TRANS/WP.29/2003/15
17 December 2002

PROPOSAL FOR DRAFT SUPPLEMENT 4 TO REGULATION No. 107

(Double-deck large passenger vehicles)

Transmitted by the Working Party on General Safety Provisions (GRSG)

"Figure 10

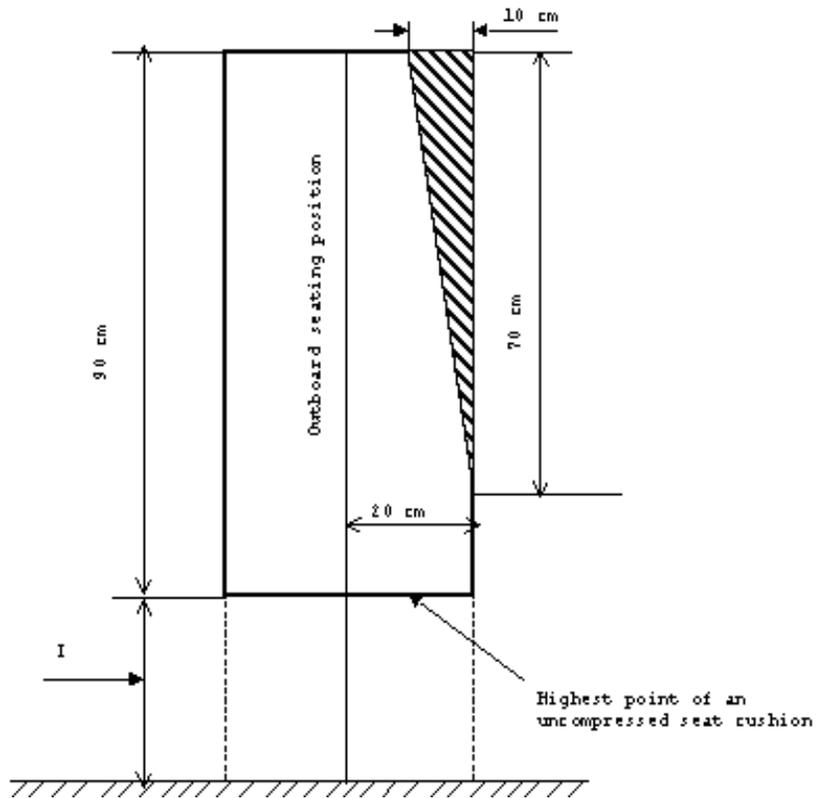
"5.7.9.6.2.2. Intrusion of a structural member provided that the intrusion is included within a triangle whose peak is situated 70 cm from the top and whose base is 10 cm in width and situated in the upper part of the space in question, adjacent to the side wall of the vehicle (see annex 3, figure 10);"

Annex 3, Figure 10, amend to read:

PERMITTED INTRUSION OF A STRUCTURAL MEMBER

(see paragraph 5.7.9.6.2.2.)

I (cm) min.
Class I	40-50
Class II	(for classes I and II min 35 cm at wheel arches and engine compartment)
Class III
